Informal Document: ACSF-15-09

Maximum allowable Override Force

Industry input to ACSF IG
15th meeting
2017, October 22-24, Bonn

Manual driving - Curve

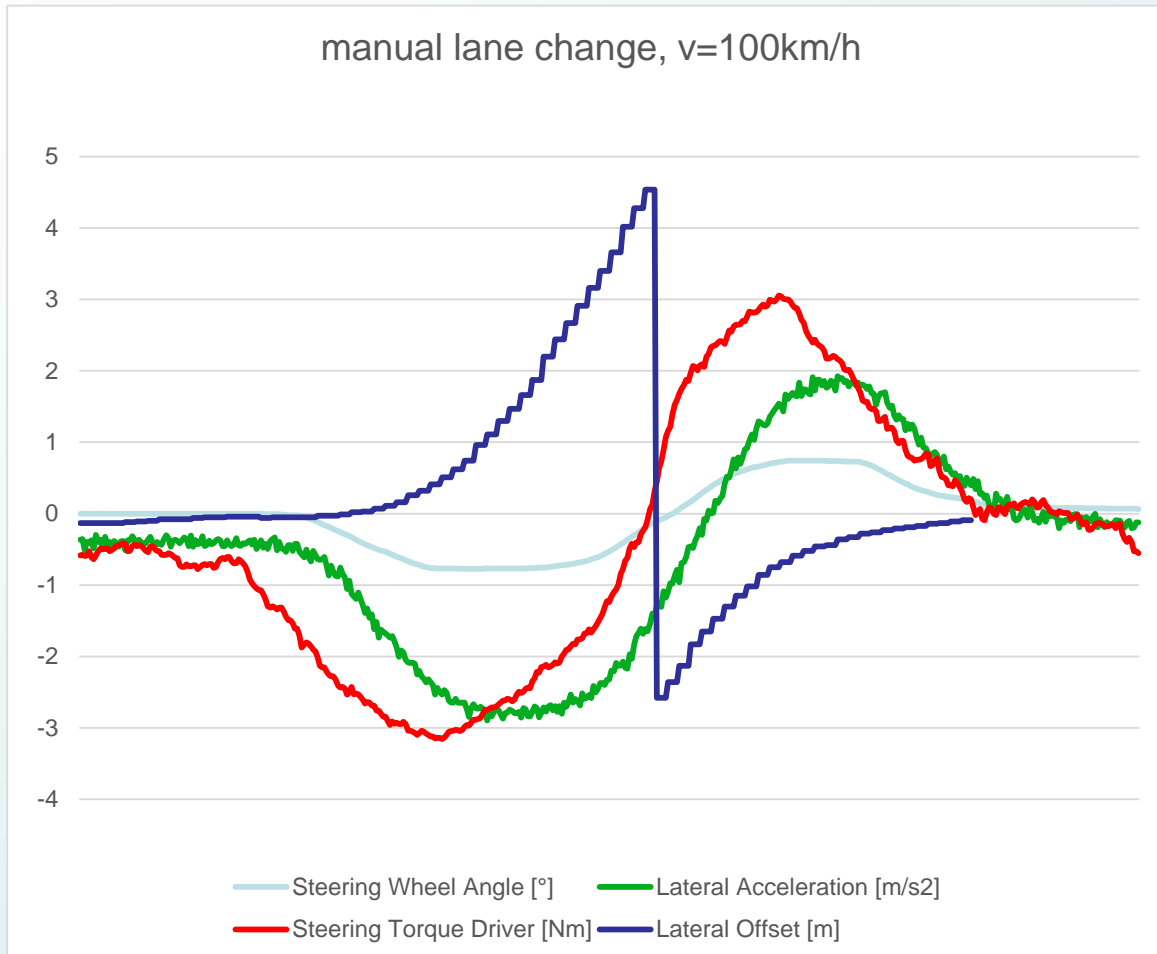
- Rural road
- Curve with radius ~160/110m
- Speed ~85km/h
- Measurement on vehicle A

Maximum value at Steering torque sensor = -4.3Nm

Calculation of the steering forces based on steering wheel radius $r = 0.15\text{m}$

$$\underline{F_{\max} = 28.6\text{N}}$$
